ARBORIST REPORT

HYATT HOUSE HOTEL AT VALLCO PARK

**WOLFE ROAD & INTERSTATE 280
CUPERTINO, CALIFORNIA
(APN 316-20-092)**

July 24, 2014

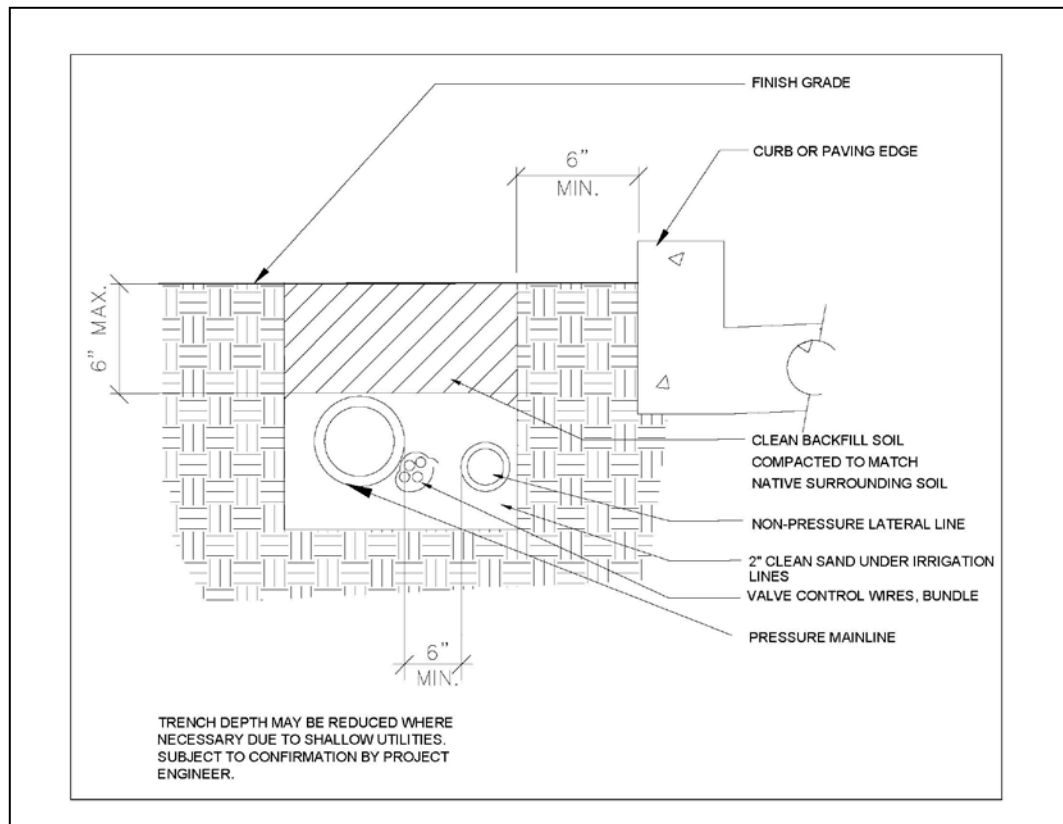
Demolition of existing curbs, planting areas, asphalt parking stall surface materials, etc. to make way for new landscaping may cause significant or severe damage to the below ground portions of trees being retained such as shamel ash at the southwest end of the site along the south boundary of the existing SEARS parking lot. The image capture at right shows a portion of project team sheet P-0609 main entry area landscaping proposed for this southwest corner area of The Hills project:

Some of the trees such as those circles drawn along the hard black line property boundary that rings the site are shamel ash specimens being retained, while other trees drawn on this sheet by the landscape architect are proposed new “in-fill” trees to augment existing screening.

New irrigation pipe trenching will need to be performed in a manner that allows for maximum lateral woody root retention when within 20 horizontal feet of trees being retained such as those shown in the image above near Stevens Creek Blvd. Toward this end, we will need to modify the standard (typ.) municipal code 18 inch depth of cover spec detail used in most jurisdictions for schedule 40 PVC piping, and instead use one of the following options:

- a. Option 1: "No Dig". This irrigation type uses flexible $\frac{1}{2}$ " diameter tubing that starts at a PVC riser at 20 feet or farther from a tree trunk of a tree being retained, and proceeds to snake over the ground to locations within 20 feet of a trunk of an existing tree where irrigation is needed. Bubblers are either affixed to the tubing itself, or to offshoot $\frac{1}{4}$ " diameter tubing with bubblers. There is also emitter line that is available in $\frac{1}{2}$ " diameter, with built in bubblers, though these tend to clog easily.

- b. Option 2: "Six Inch Cover" Rule: Use a modified specification such as a setup where a maximum of six (6) inches of soil cover is specified as the maximum allowable vertical space between top of newly installed PVC irrigation pipe and original soil grade elevations, within 20 feet of a tree trunk. At right is a sample specification side cut detail showing this setup that was used for a recent project where new landscaping was to be installed within 20 feet of valuable cedar specimens being retained in Palo Alto, California. See sample spec image below (copyright Sandis Civil).
